## REPORT OF PROJECT

Confirmatory Test of Production Model Rifle, 7.62mm, M14

REPORT OF PROJECT NR 2869  
CONFIRMATORY TEST OF PRODUCTION MODEL RIFLE, 7.62MM, M14  
(DA PROJECT 502-08-006) (U)

ANNEX C-1

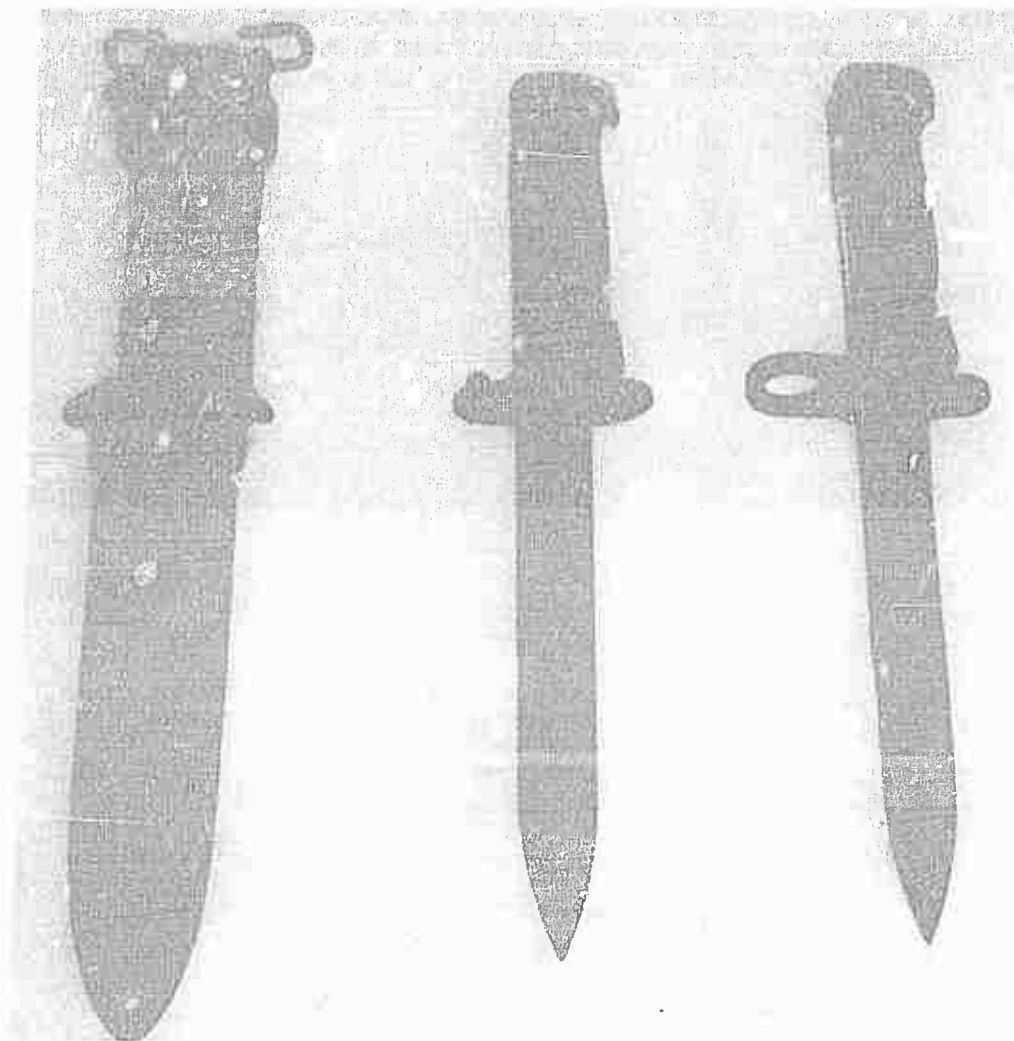
(d) Modification to the floor plate of the magazine (Annex C-1).

Bottom Center - Position of magazine floor plate after firing.

AMEX C-3

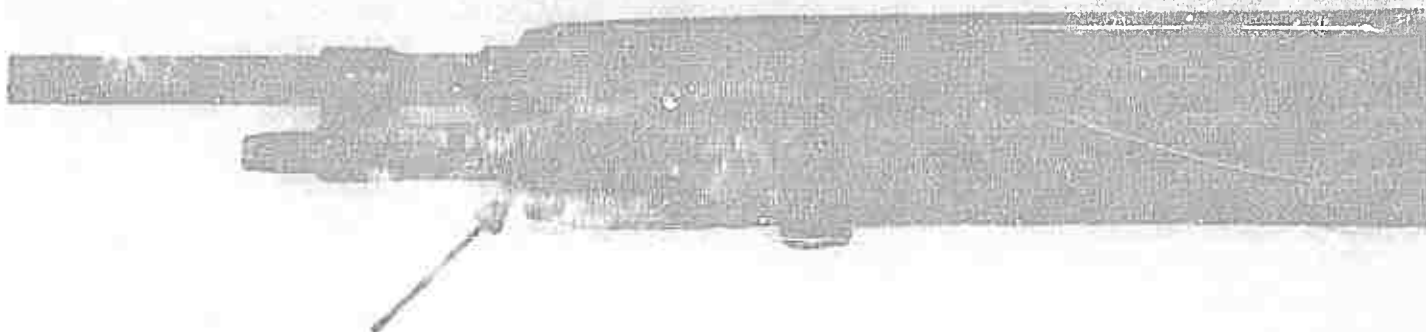
<u>Minor Deficiency</u>	<u>Results</u>	<u>Suggested Modification</u>
15. Maintenance equipment has too many parts (Annex C-3).	Parts are easily lost or are unnecessary.	Correct by eliminating bolt disassembly feature and plastic cap. Make handle of cleaning rod in one piece by having wrench and screwdriver tip as integral part of handle.

<u>Minor Deficiency</u>	<u>Results</u>	<u>Suggested Modification</u>
16. Tab on cleaning rod case easily punctured by sections of cleaning rod (Annex C-3).	Reduces life of cleaning rod case.	Reinforce tab of case.

ANNEX C-4

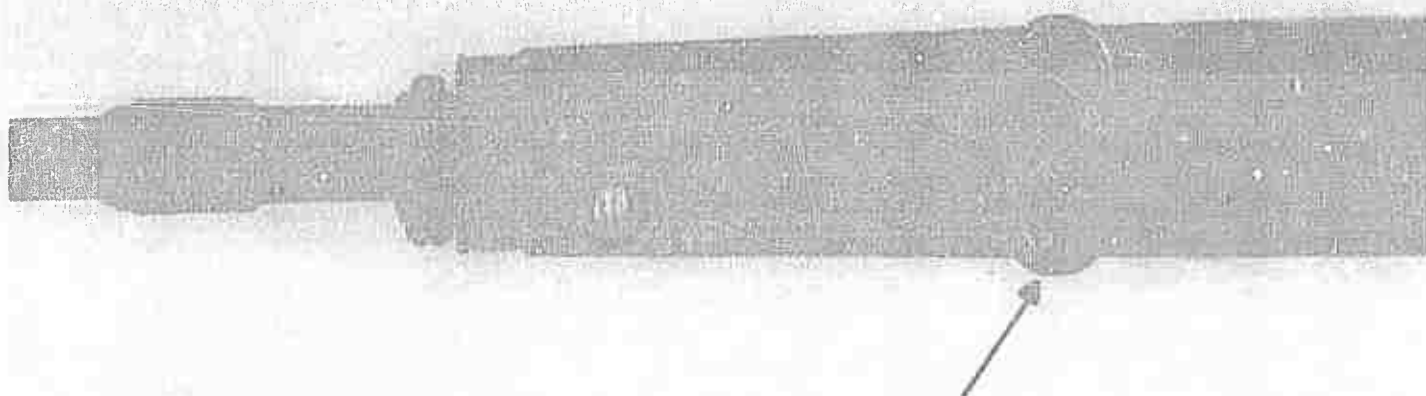
8. Forward stock retaining flange lacks the strength required to allow execution of the bayonet slashing movement (Annex C-4).	Allows rifle stock and other components to separate.	Enlarge forward stock retaining flange to provide stronger connection.

Stock of rifle, separated as the result of  
executing the bayonet slash.
